CITY OF VANCOUVER
POLICY REPORT
DEVELOPMENT AND BUILDING

TO: Vancouver City Council
FROM: Director of Current Planning
SUBJECT: CD-1 Rezoning – 5541-5675 Willow Street

CROSS SECTIONS
SITE SECTION A;
SITE SECTION B;
SITE SECTION C;
SITE SECTION D

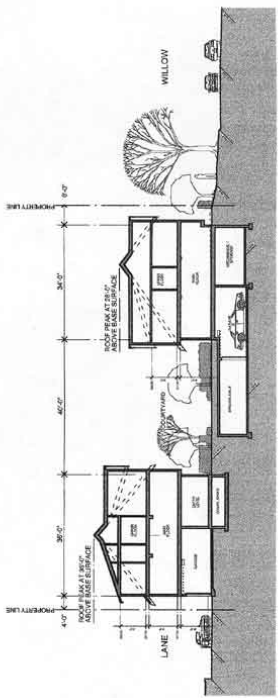
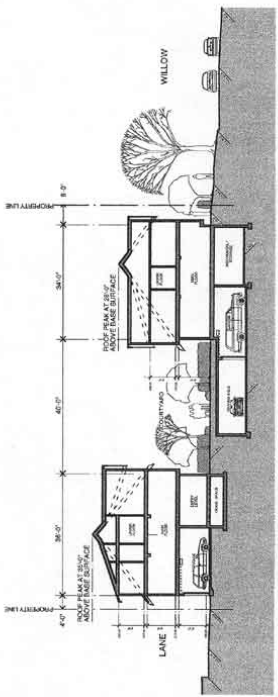
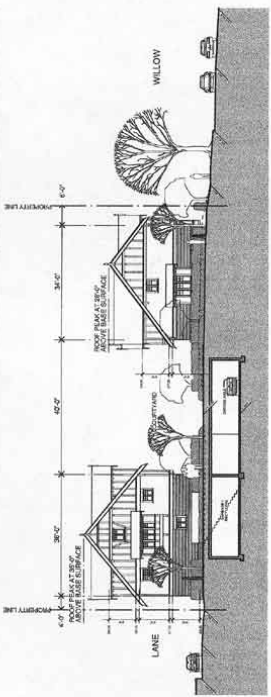
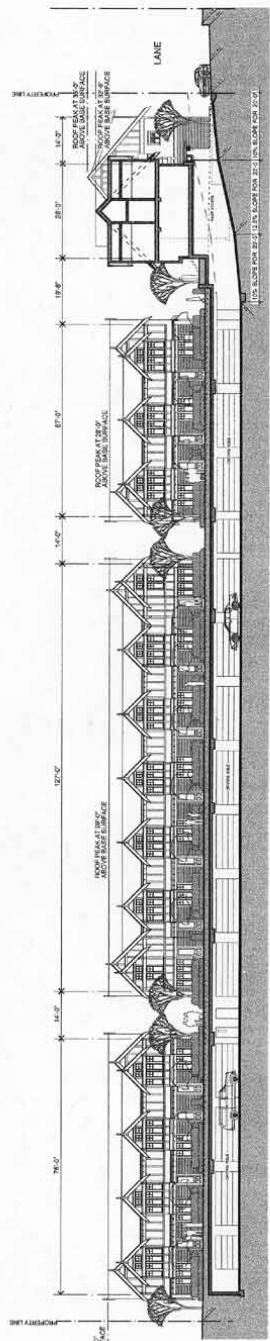
- concerns expressed about the south elevation both in terms of planning and with respect to the unit over the ramp and the height and massing of the southeast unit;

In general, the massing was thought to work quite well with the exception of the south elevation where the units seem to be "squeezed" and have an awkward orientation to the courtyard. The three storey massing of the unit at the southeast corner was also thought to be negative, with recommendations to reduce this unit to two storeys to match the rest of the massing along Willow Street. Another suggestion was to absorb the south units into the front and rear rows, which would also allow the creation larger gaps and east-west links through the site.

- (i) Design development to reduce the floor area to comply with the maximum 1.00 FSR.
- (ii) Design development to comply with the revised north side-yard setback of 3.05 m (10 ft.).
- (iii) Design development to the building massing and height, south elevation.

Note to Applicant: Reduce height of southeast unit to 2½ storeys as seen from Willow Street. Building massing to be more compatible with the east and west facing units. Consider reorientation of buildings to the courtyard, and reconfiguring the parking ramp as necessary to reduce visual impact where possible.
